BID ADDENDUM NO. 2

OWNER: EDGEMONT UNION FREE SCHOOL DISTRICT

PROJECT NAME: ADMINISTRATION BUILDING ADDITION,
SITE IMPROVEMENTS & RELATED WORK

DATE: March 18, 2025

DRAWING NO.
SK-E1.0

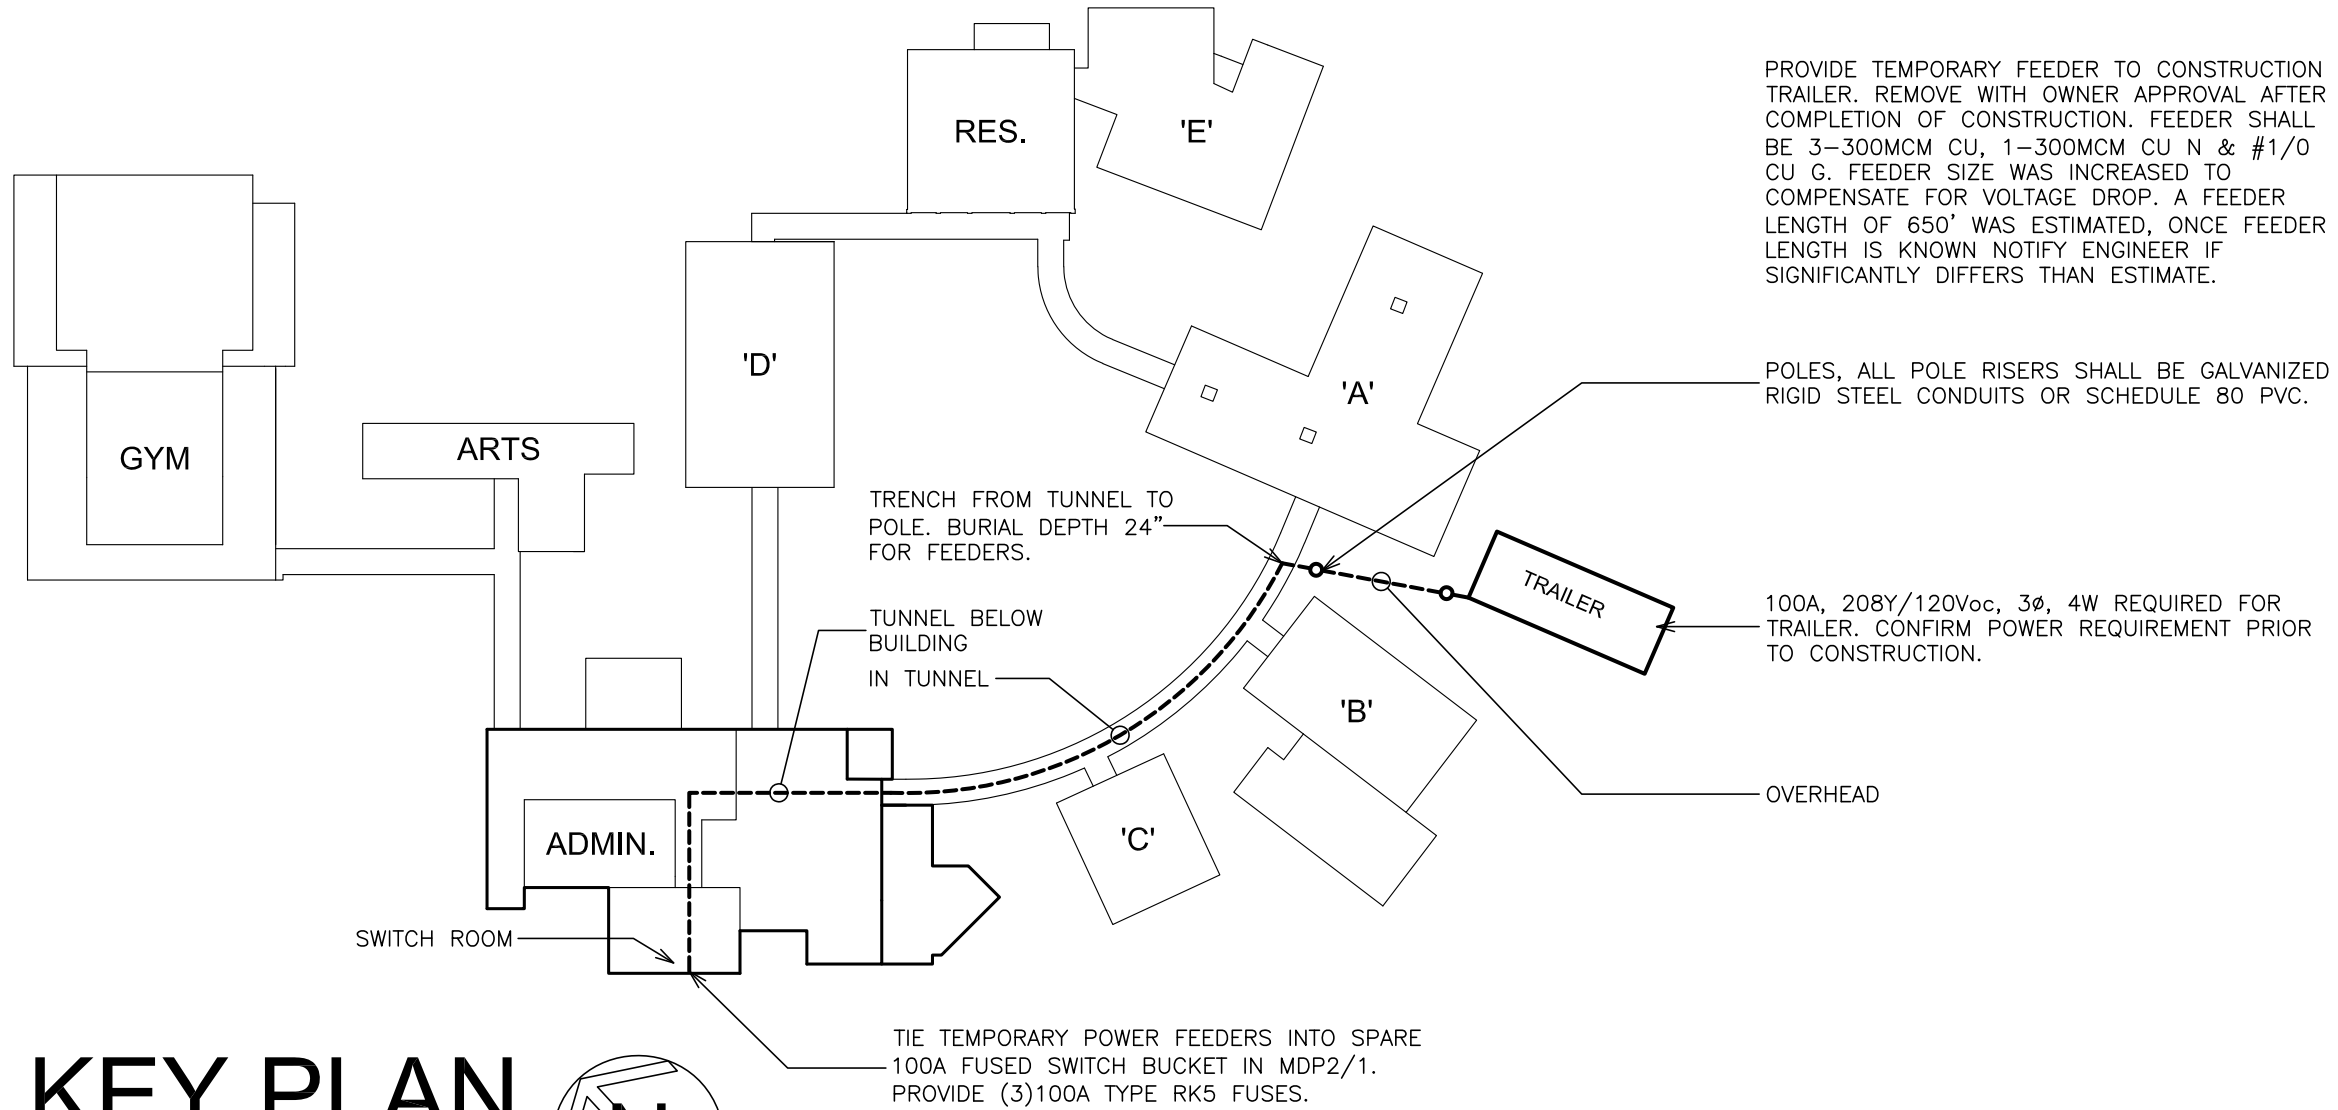
DRAWING E001 – ELECTRICAL NOTES, LEGEND, DRAWING SCHEDULE, AND KEY PLAN
ADD Key Plan as shown on Sketch SK-E1.0 attached to this addendum.

DATE	ISSUED TO
03-18-2025	ADDENDUM #2
03-12-2025	ADDENDUM #1
02-28-2025	BID SET
06-10-2022	S.E.D. SUBMISSION
	DATE
	ISSUED TO
SHEET SIZE 30"x42"	DRAWING NO. E002
SCALE AS NOTED	FILE NO. 24529.02
DRAWN BY LFG

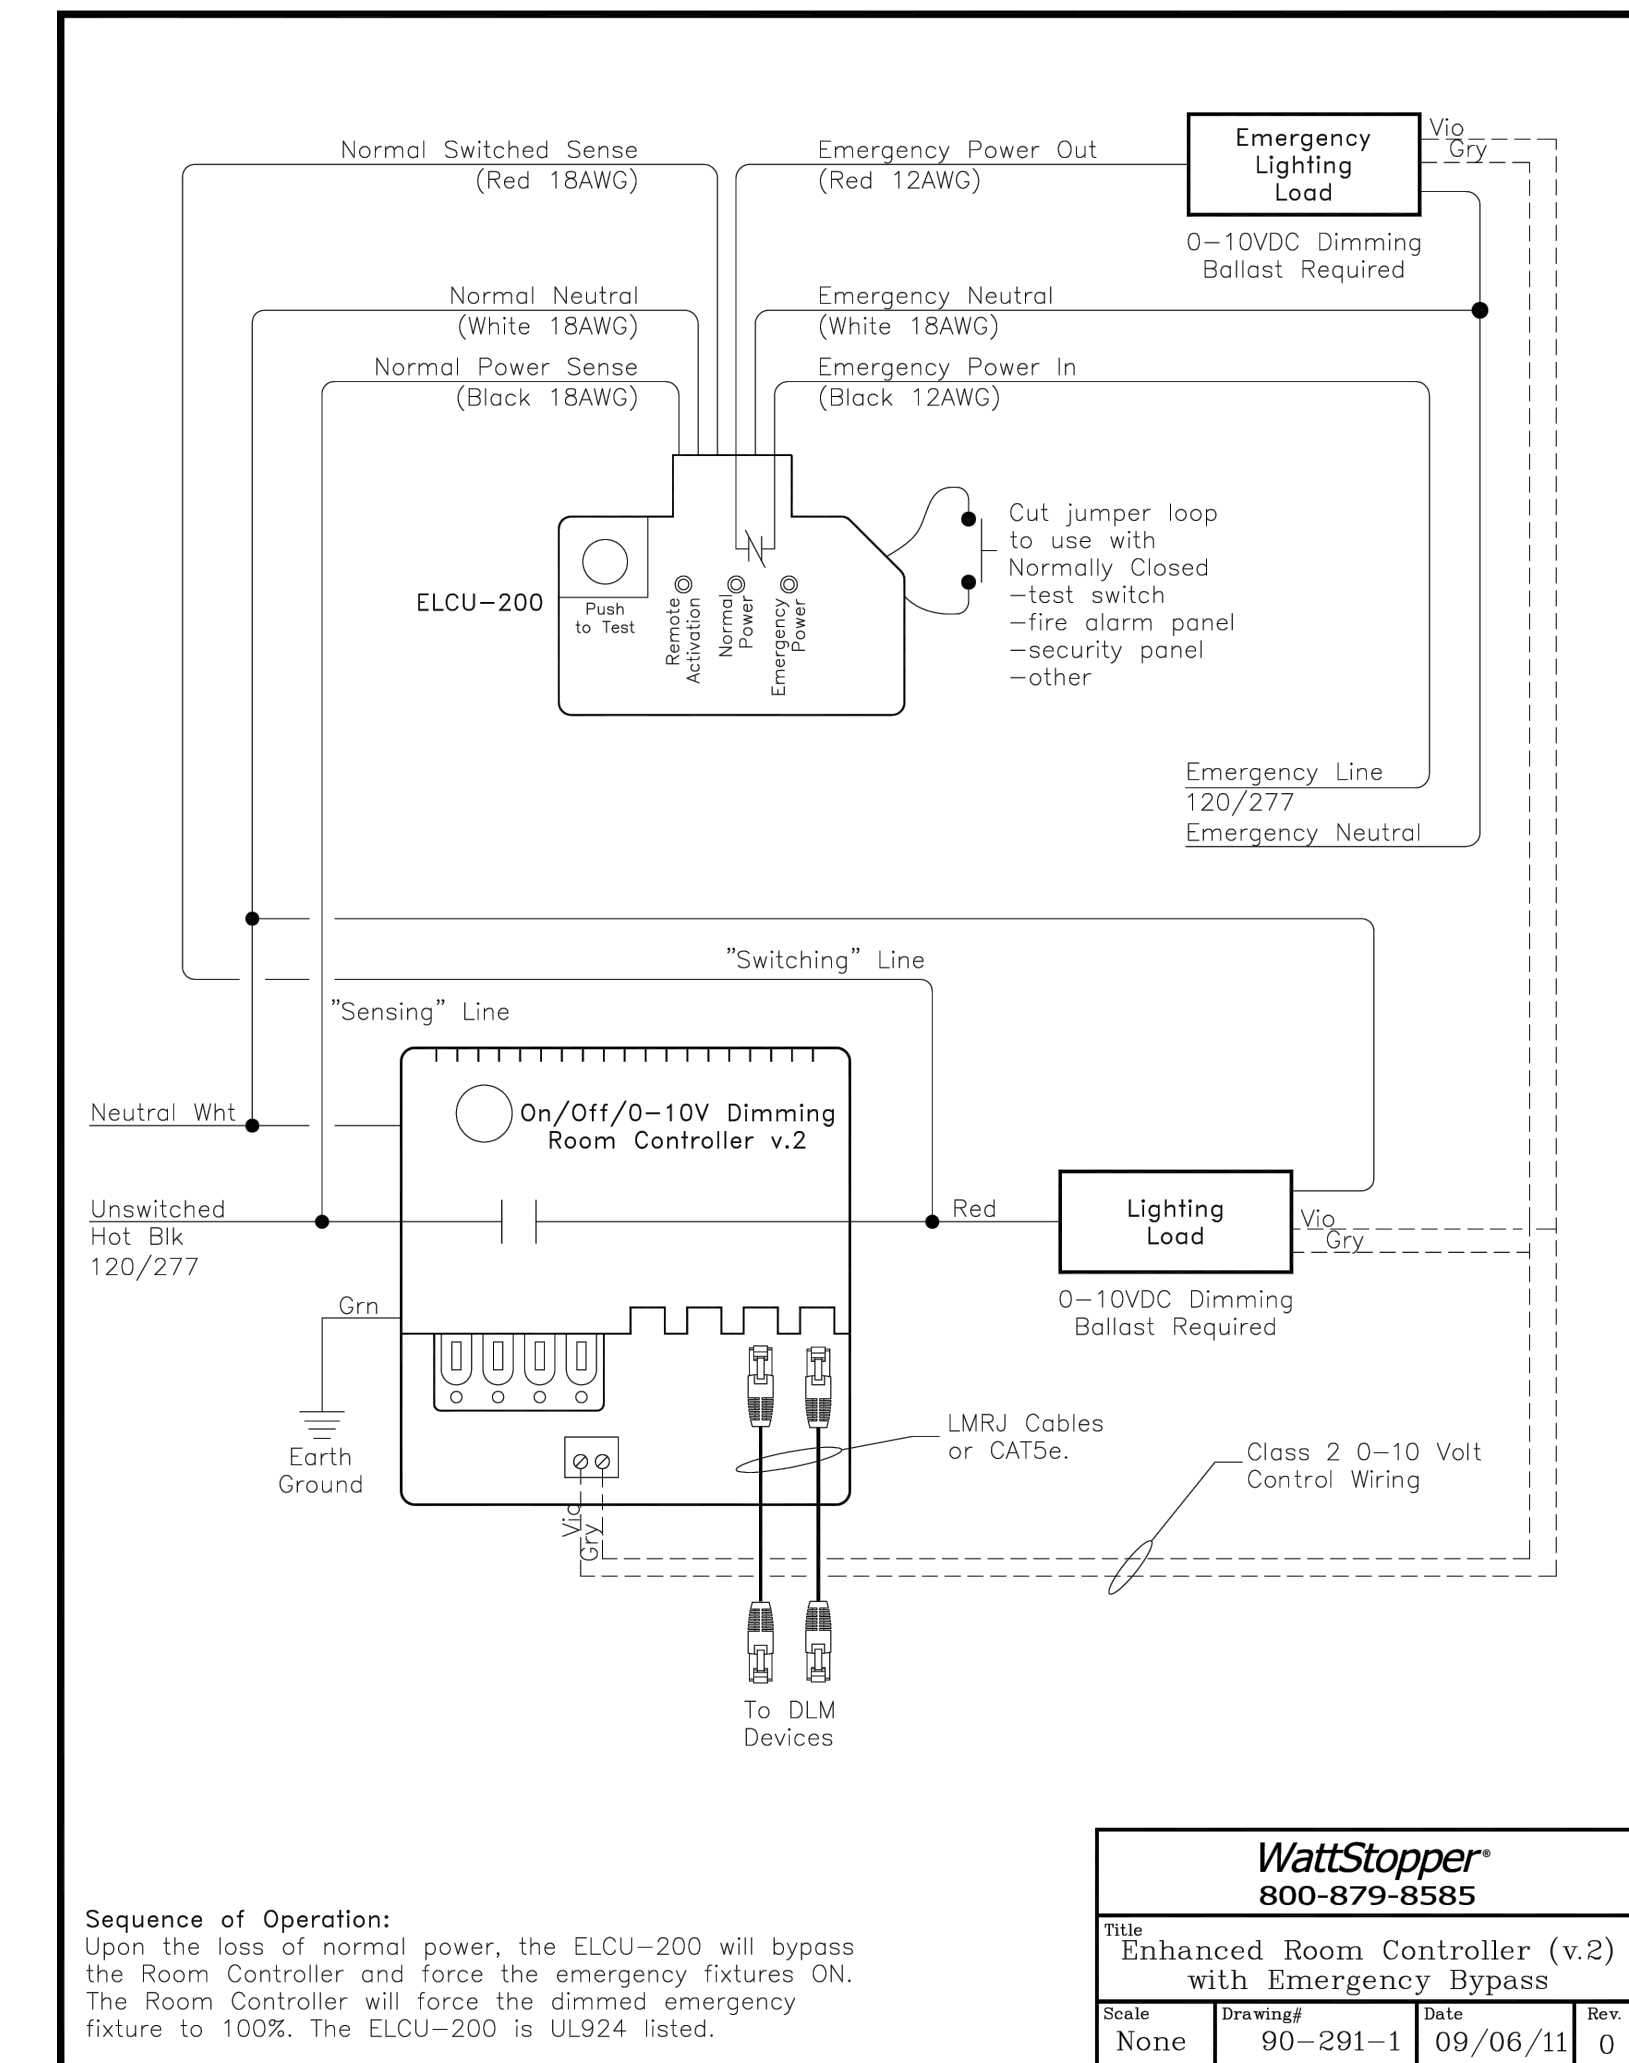
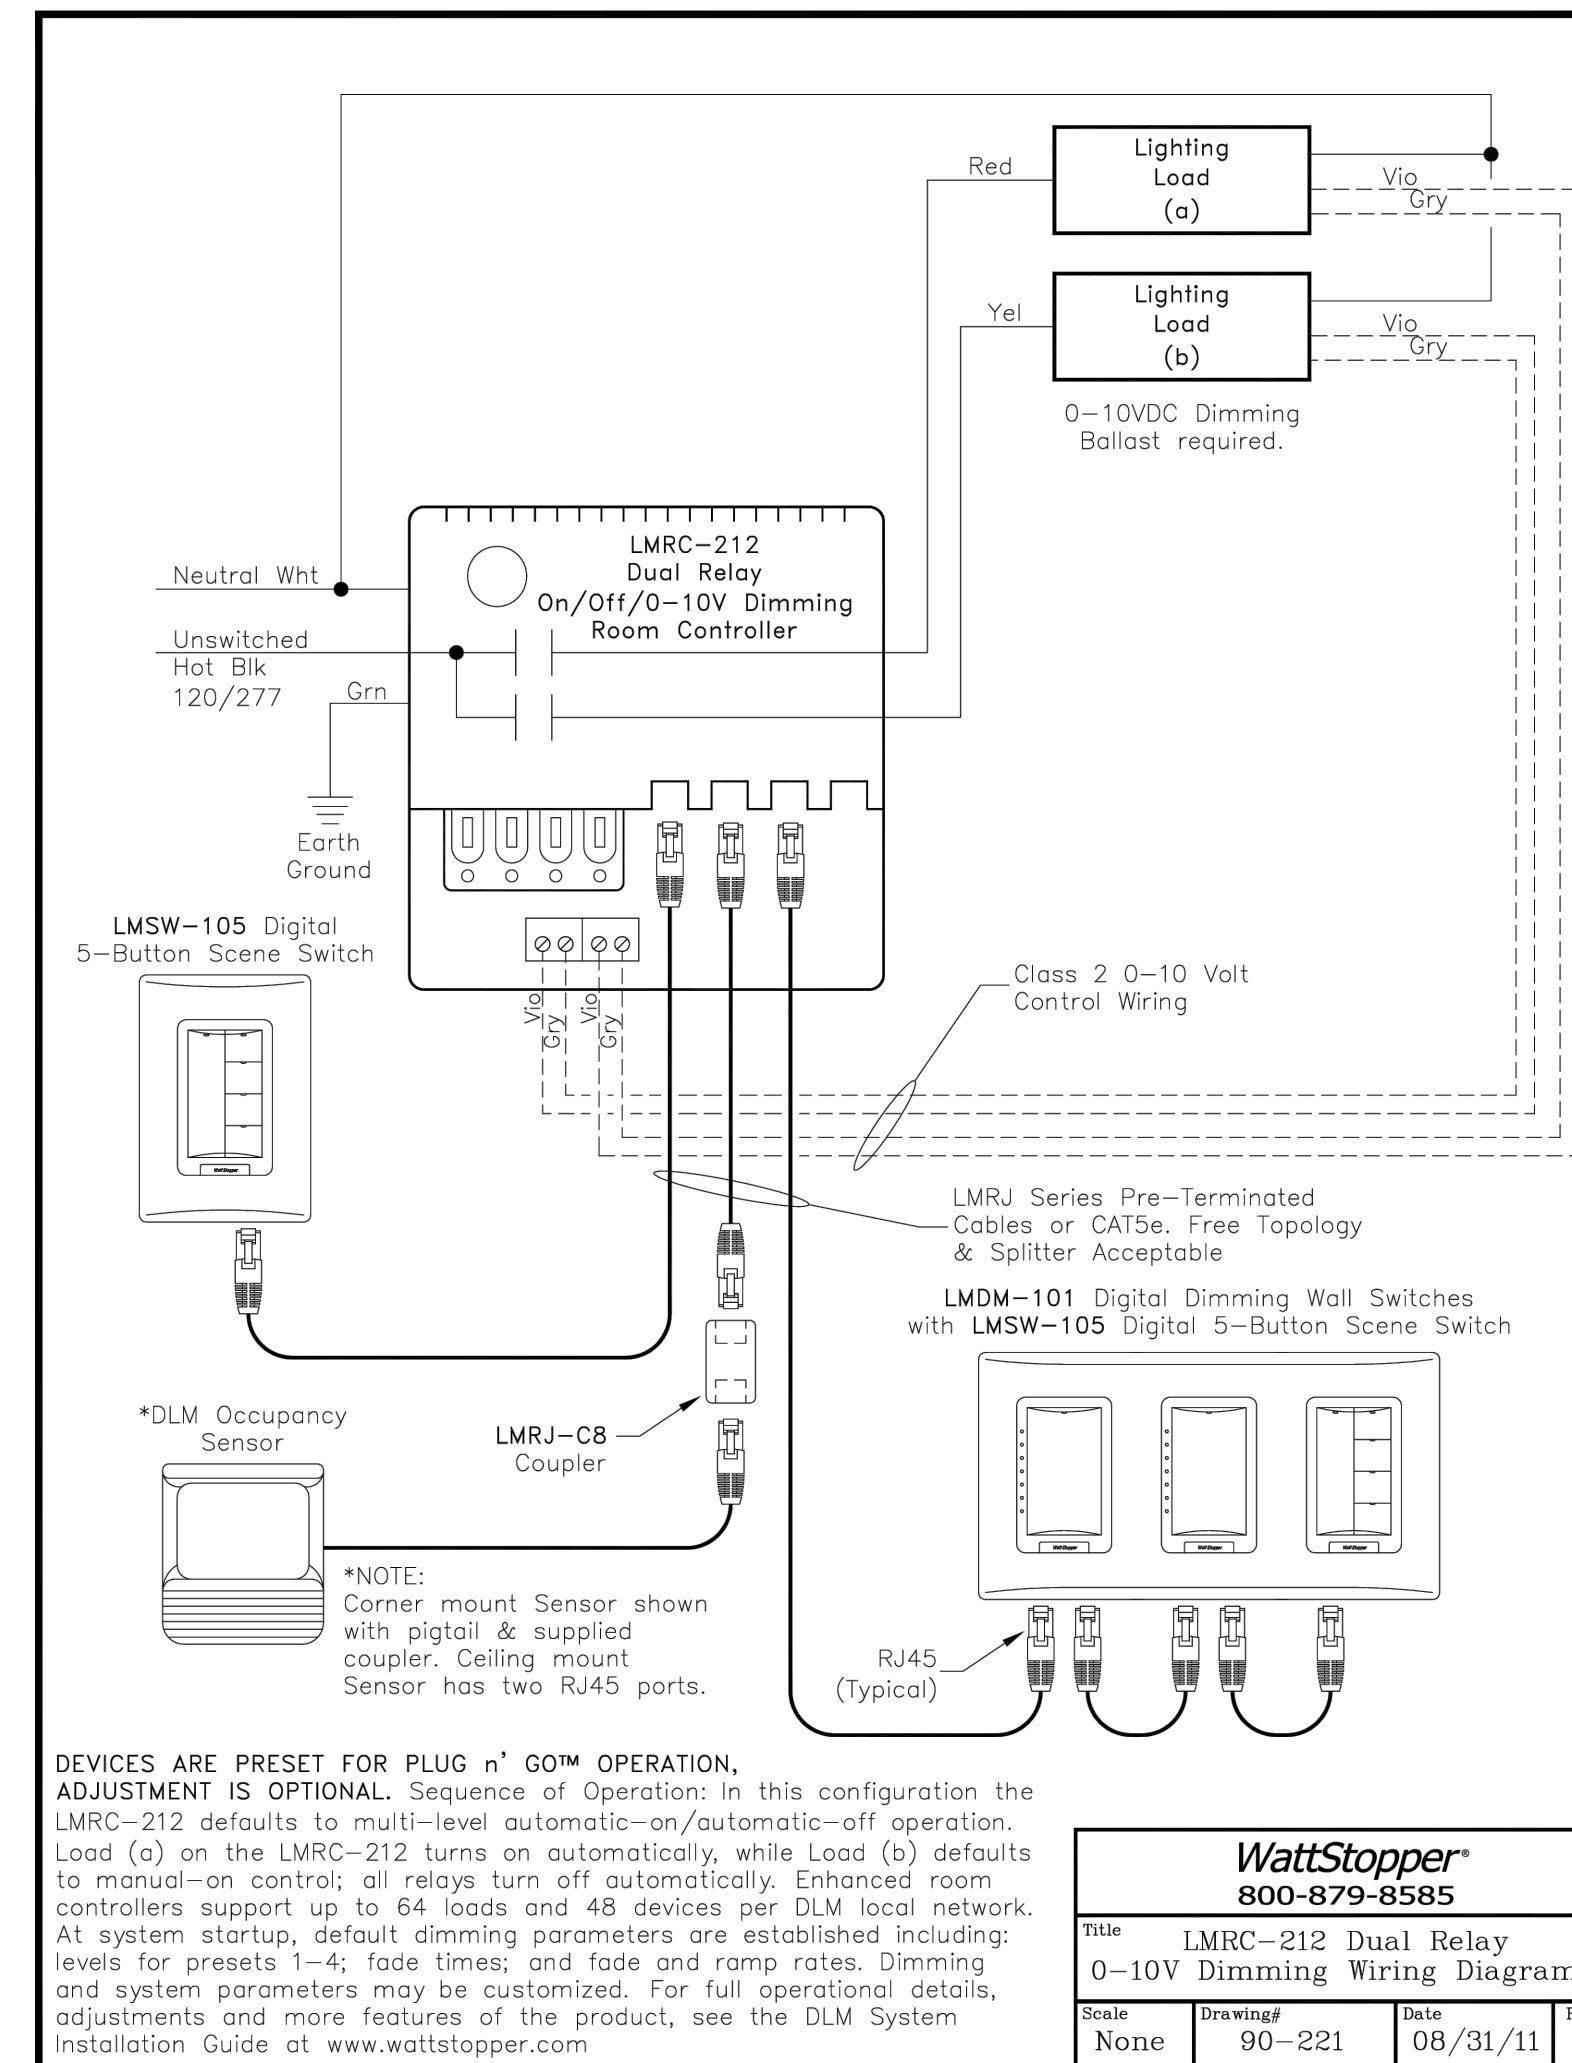
DRAWING E002 – ELECTRICAL LIGHTING FIXTURE SCHEDULE, LIGHTING CONTROL SCHEDULE, & LIGHTING CONTROL DETAILS
REVISE Lighting Fixture Schedule as shown on revised drawing attached to this addendum.

DRAWING TITLE
**LOWER LEVEL ELECTRICAL
LIGHTING PLAN**

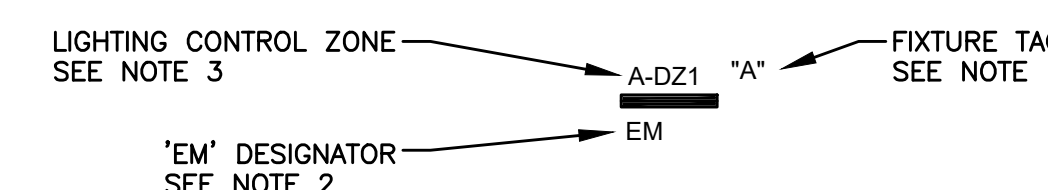
DRAWING AD E120 – LOWER LEVEL ELECTRICAL LIGHTING PLAN
REVISE exterior light fixtures as shown on revised drawing attached to this addendum.

PROVIDED BURIED CIRCUIT CONDUCTORS IN PVC. BURIAL DEPTH PER NEC TABLE 300.5. PROVIDE PHOTOCELL MOUNTED TO BUILDING CONTROLLING STEP FIXTURES.
